# Access Compliance Report

## Public Rights-of-Way (Curb Ramps)

Intersection ID: 31510	Main Street: GRIER_SPRINGS_LN	Cross Street: CONNELL_GREEN_DR	Location: SW
ADA ID: 1567F813E978	Ramp Type: BlendTrans1	Initial Pass/Fail: Fail	Overall Compliance: No
		Severity Score: 10

### Codes/Mitigation Info/Possible Solution

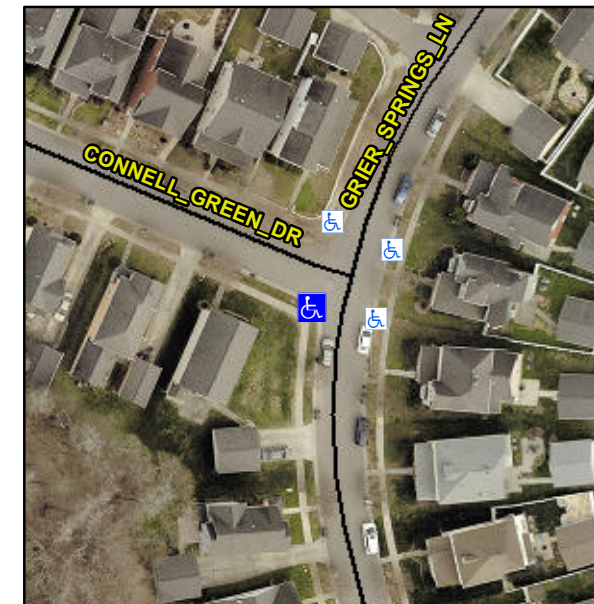
Compliance	Description	Data	Compliance	Description	Data
N/A	Ramp Length (in)	60.0	Yes	BlendTrans Slope (%)	2.8
No	Ramp Width (in)	45.0	No	BlendTrans XSlope (%)	3.0
N/A	Flare Type LT	N/A	N/A	Flare Type RT	N/A
N/A	Flare Slope LT (%)	N/A	N/A	Flare Slope RT (%)	N/A
N/A	Flare Traversable LT?	N/A	N/A	Flare Traversable RT?	N/A
N/A	Landing Length (in)	N/A	N/A	DWS Provided?	N/A
N/A	Landing Width (in)	N/A	N/A	DWS Contrast?	N/A
N/A	Landing Slope (%)	N/A	N/A	DWS Length (in)	N/A
N/A	Landing X Slope (%)	N/A	N/A	DWS Full Width?	N/A
N/A	Landing Curb? (Y/N)	N/A	N/A	DWS Offset (in)	N/A
N/A	Shared Landing?	N/A			
N/A	Gutter Ponding?	N/A	N/A	Gutter Slope (%)	N/A
N/A	Gutter Lip Ht (in)	N/A	N/A	Gutter X Slope (%)	N/A
N/A	Painted X Walk1?	No	N/A	Painted X Walk2?	No
	X Walk 1 Direction	To SE		X Walk 2 Direction	To N
	X Walk 1 Width (in)	N/A		X Walk 2 Width (in)	N/A
	X Walk 1 Slope (%)	3.8		X Walk 2 Slope (%)	0.6
	X Walk 1 X Slope (%)	0.2		X Walk 2 X Slope (%)	3.2

N/A	Ramp inside XWalk1?	N/A	N/A	Ramp inside XWalk2?	N/A
	Road Slope (%)	1.8		Clear Space?	N/A
	Road X Slope (%)	2.3	N/A	Clear Space to XWalk (in)	N/A
N/A	Any Obstructions?	N/A	N/A	Storm Grate/Utility Hazard?	N/A
	Obstruction Type			Storm Grate/Utility Type	
		N/A			N/A
			Yes	Surface Condition? (G/P)	Good
			N/A	Curb Slope (%)	N/A

**Remove & Replace Curb Ramp With Two New Directional Ramps or Equivalent.**

**R304.5.1, R304.5.3**
